PL201900032
PL2019-32

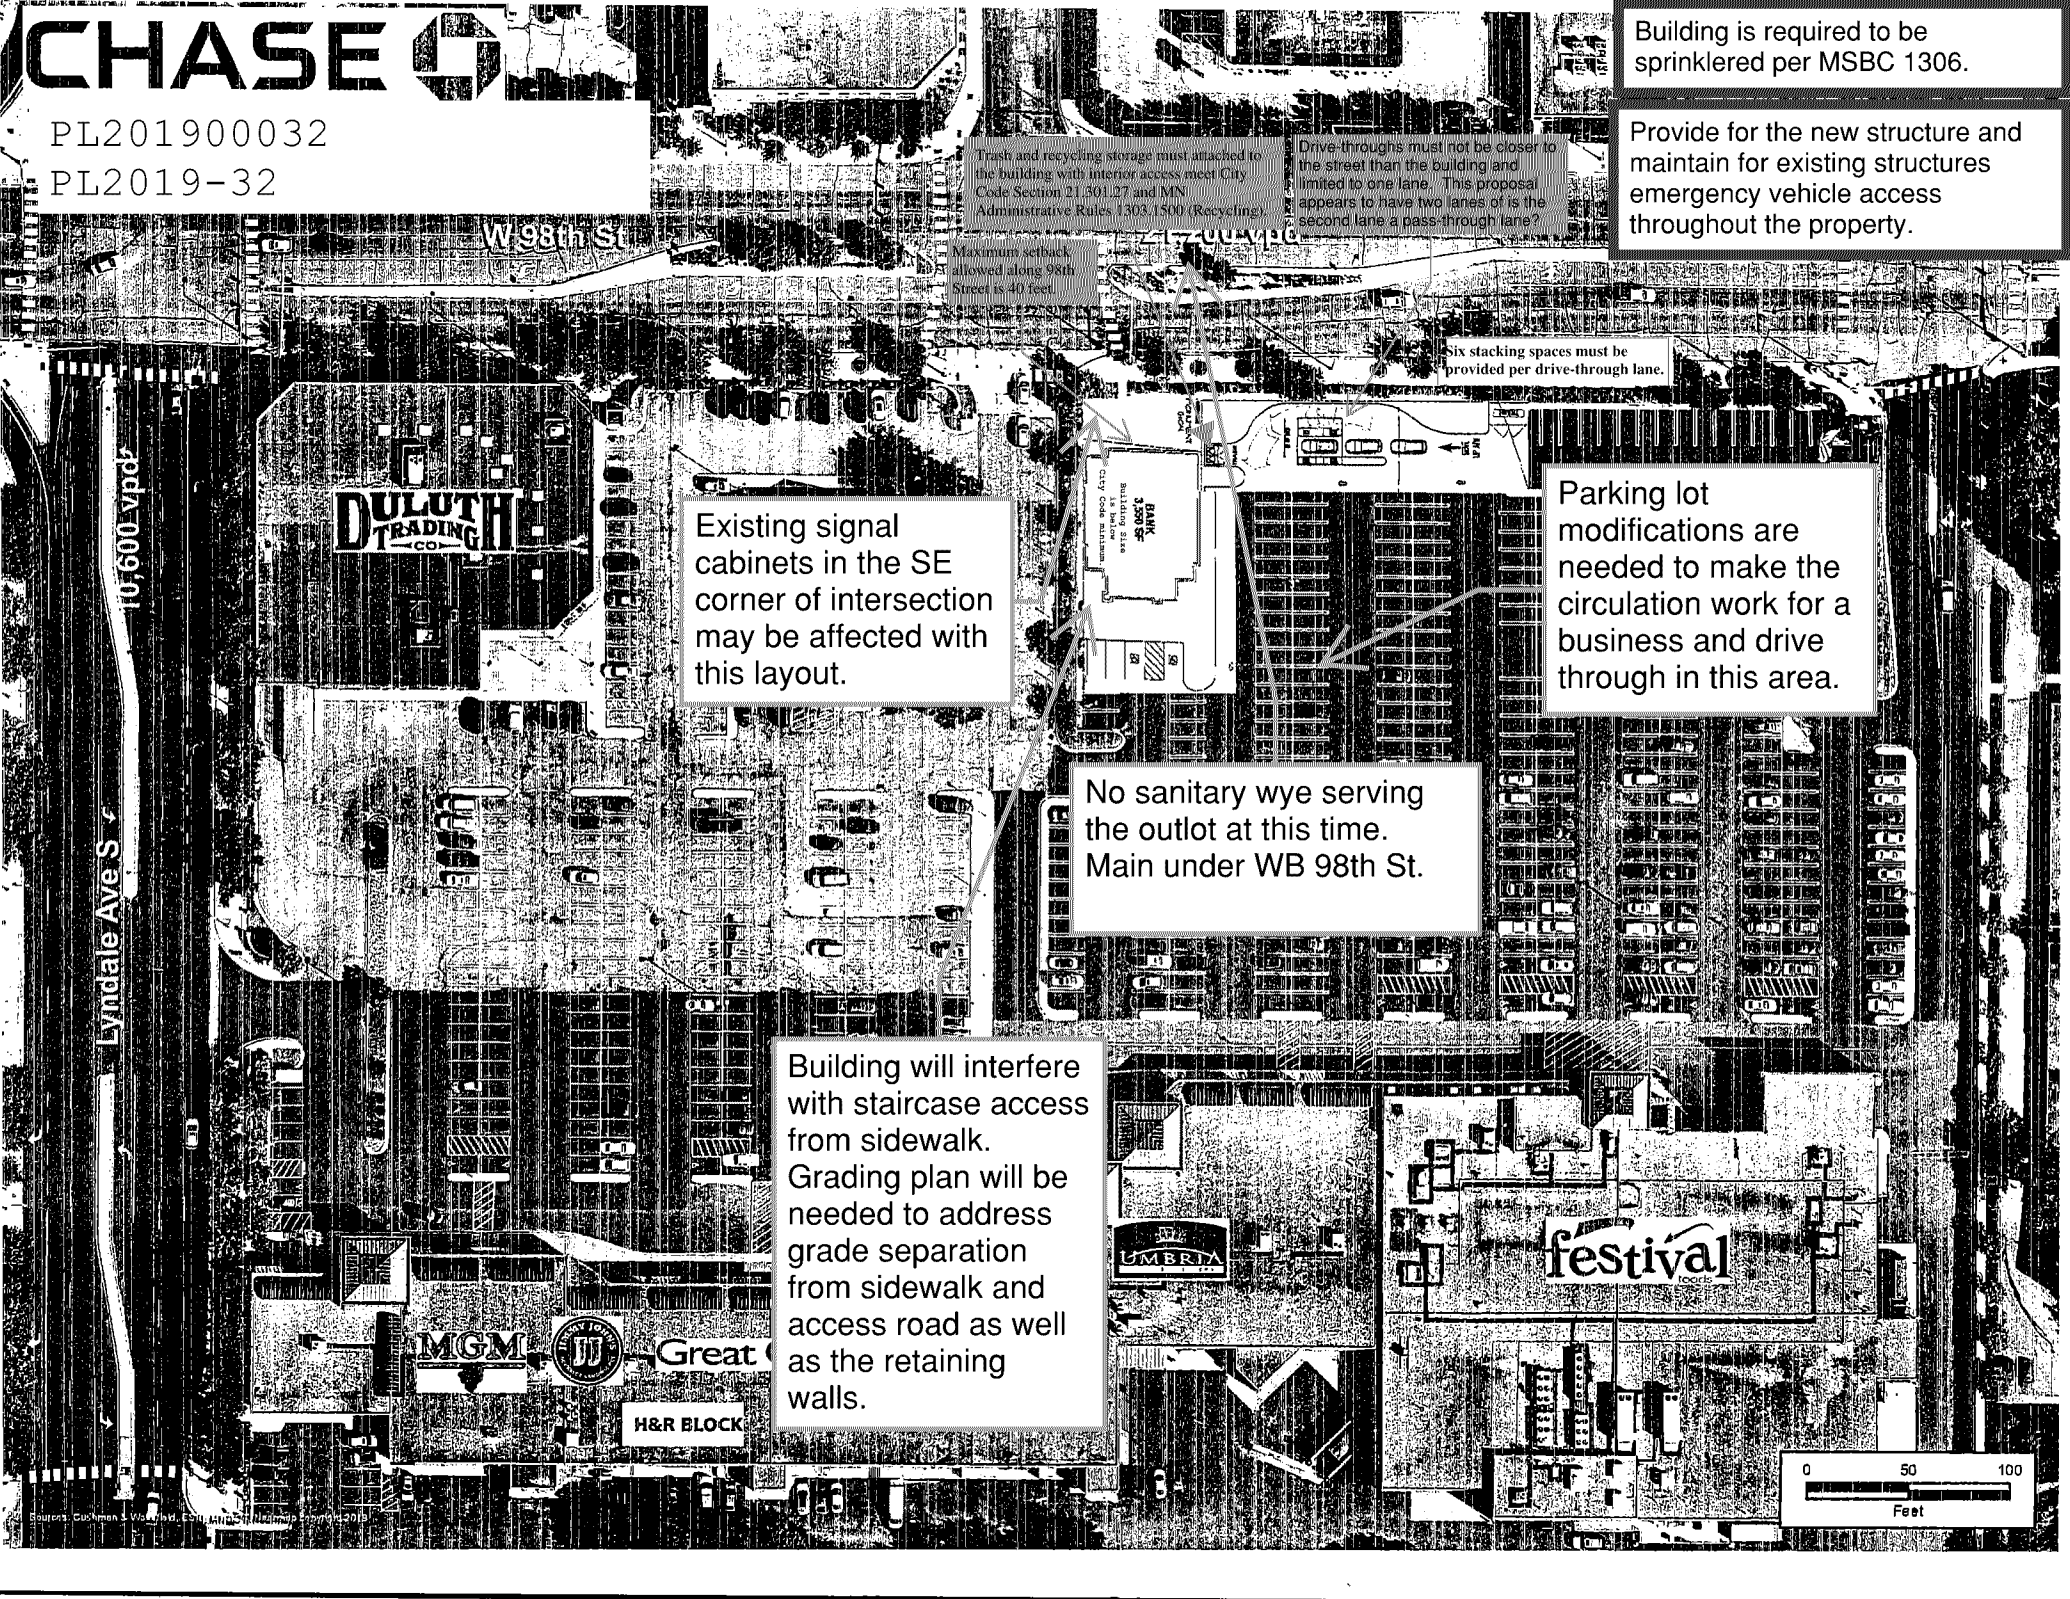
Building is required to be sprinklered per MSBC 1306.

Provide for the new structure and maintain for existing structures emergency vehicle access throughout the property.

Trash and recycling storage must be attached to the building with interior access meet City Code Section 21.501.27 and MN Administrative Rules 1303.1500 (Recycling).

Drive-throughs must not be closer to the street than the building and limited to one lane. This proposal appears to have two lanes or is the second lane a pass-through lane?

Maximum setback allowed along 98th Street is 40 feet

Six stacking spaces must be provided per drive-through lane.

Existing signal cabinets in the SE corner of intersection may be affected with this layout.

Parking lot modifications are needed to make the circulation work for a business and drive through in this area.

No sanitary wye serving the outlot at this time. Main under WB 98th St.

Building will interfere with staircase access from sidewalk. Grading plan will be needed to address grade separation from sidewalk and access road as well as the retaining walls.
